RESPONSE TO REQUEST FOR ADDITIONAL INFORMATION

APR1400 Design Certification

Docket No. 52-046

RAI No.: 176-8089
SRP Section: 03.11 – Environmental Qualification of Mechanical and Electrical Equipment
Application Section: 03.11
Date of RAI Issue: 08/31/2015

Figure 3A-1 A Simplified Flowchart for Determination of Accident TIDs

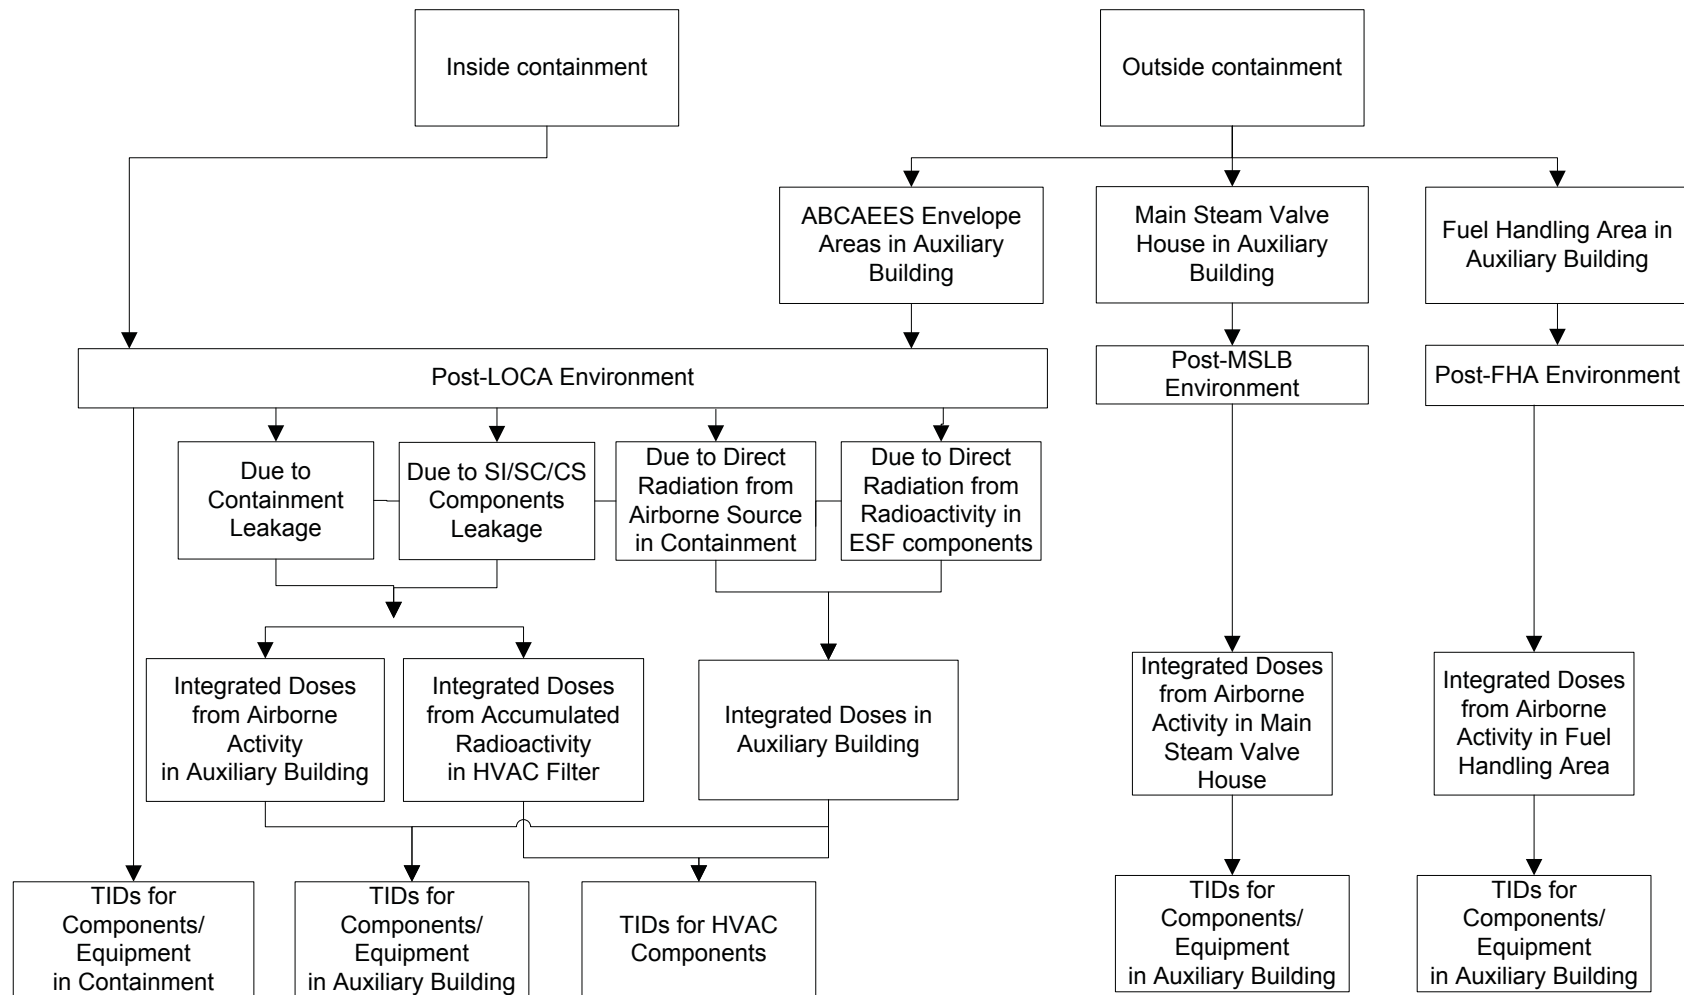
6. Please indicate if airborne activity associated with leakage from recirculation systems has been considered in the total integrated dose values for rooms and cubicles in APR1400-E-X-NR-14001-P, Table 4? If so, please describe the methods, models, and assumptions used in determining the airborne activity contributions associated with these sources to the total integrated dose values.

The calculation pathway is depicted as “Due to Containment Leakage” and “Integrated Doses from Airborne Activity in Auxiliary Building” in Figure 1 in Appendix 3A. The input parameters and assumptions, method, and model are described in Sub-sections 2A, and 2.B.1 and 2.B.2, and Tables 2 in Appendix 3A. The RUNT-G and ISOSHL D models for TIDs are depicted in Figures 4 and 5. A discussion of the direct radiation is included in Subsection 2.B.3 and 2.B.4.
